April 14, 2026  
Subject: Intersection Improvements  
with Mast Arm Replacements  
WIN: 028480.00  
Location: Brewer  
**Amendment No. 1**

## BREWER PENOBSCOT COUNTY TRAFFIC SIGNAL AND FLASHING BEACON DESIGN WIN: 28480.00

**BREWER  
N MAIN ST  
TRAFFIC SIGNAL PLAN**

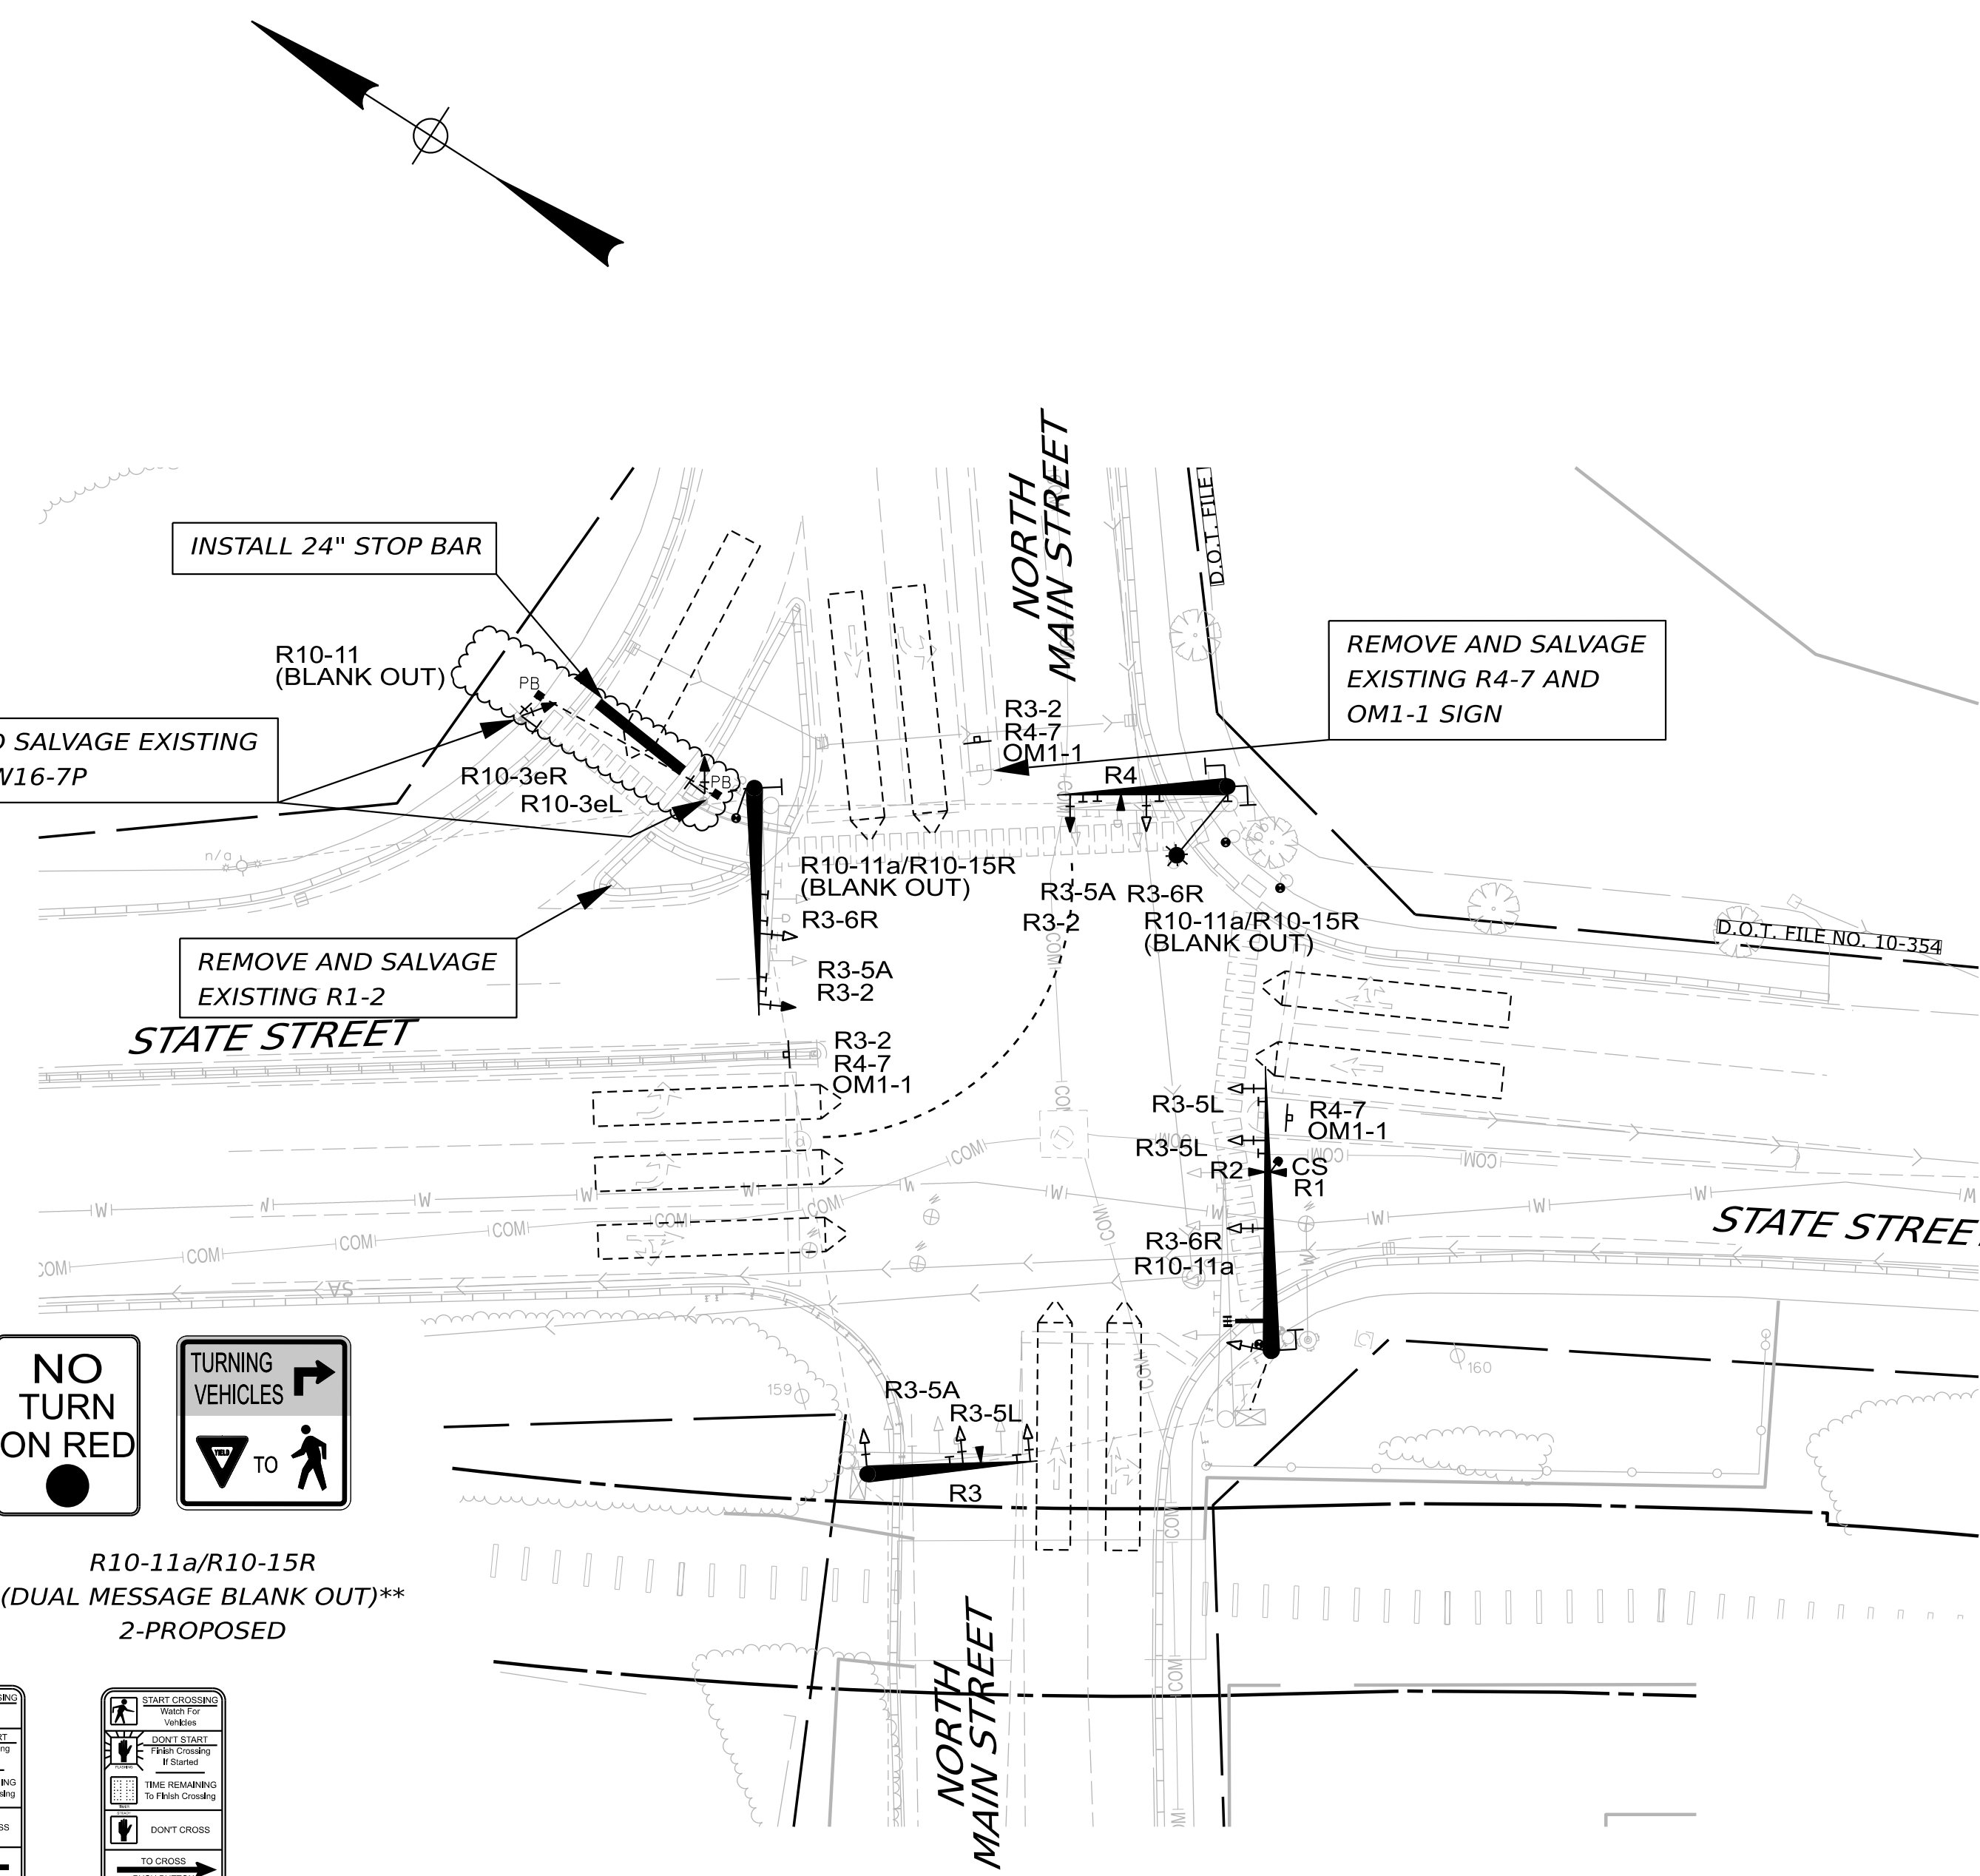
**Question:** Please provide a mounting height and luminaire arm length for the luminaire to be mounted to the 30' mast arm.

**Question:** Please provide sign sizes for the proposed blank-out signs.

**Question:** How will the conduit to control the signals B4 and B5 be paid for? Is the intent to directionally drill or is trenching acceptable?

**Response:** 40' height to luminaire on the 36' pole, 20' arm length.

**Response:** Two proposed 30"x30" dual message blank out signs, one proposed 30"x36" blank out sign.

**Response:** The City places a five year moratorium for street openings after paving. There has not been any paving or reconstruction of the roadway within the last five years, therefore trenching is acceptable. It should be noted that the conduit between B4 and B5 has been revised to be Item 626.221.
